# UNITED STATES PATENT AND TRADEMARK OFFICE

APPLICATION NO.	FILING DATE	FIRST NAMED INVENTOR	ATTORNEY DOCKET NO.	CONFIRMATION NO.
10/613,646	07/02/2003	Burns Phillips	50243-0001	4622
23424	7590	09/21/2006	EXAMINER	
WALLENSTEIN & WAGNER, LTD. 311 SOUTH WACKER DRIVE 53RD FLOOR CHICAGO, IL 60606			REIMERS, ANNETTE R	
			ART UNIT	PAPER NUMBER
			3733

<b>Office Action Summary</b>	<b>Application No.</b>	<b>Applicant(s)</b>
	10/613,646	PHILLIPS ET AL.
	<b>Examiner</b>	<b>Art Unit</b>
	Annette R. Reimers	3733

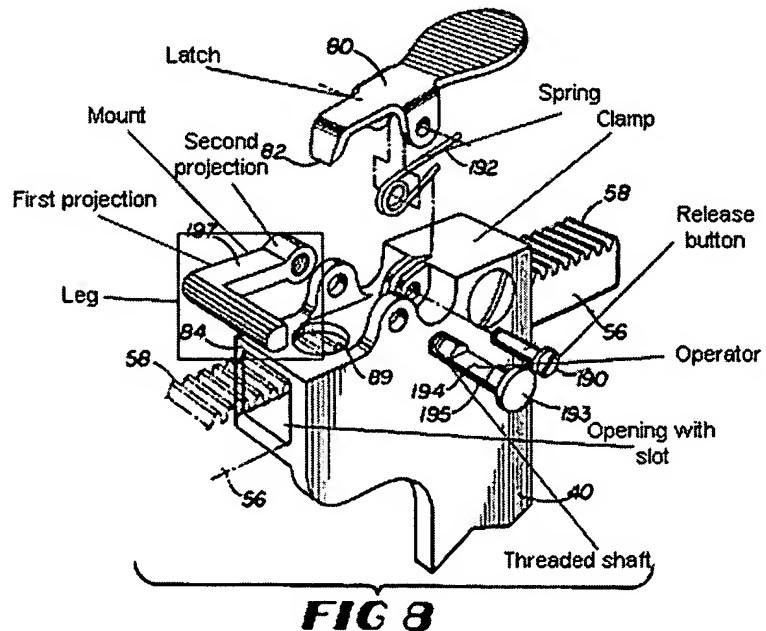
Furnish discloses various embodiments of a surgical retractor comprising a clamp having an opening with a slot having an upper and a lower surface, a latch is pivotally connected to the clamp, a spring biases the latch, a release button disengages the latch, an angularly adjustable leg is pivotally coupled to the clamp and extends cantileveredly away from the clamp (see figures 9 and 10), wherein the leg has a mount, wherein the mount has a first and a second projection, an operator is connected to the leg, wherein the operator has a threaded shaft and a release button, e.g.: 193 in combination with 194 and 195 of figure 8 below), and the latch engages a tooth on the arm (see figures 9 and 10).
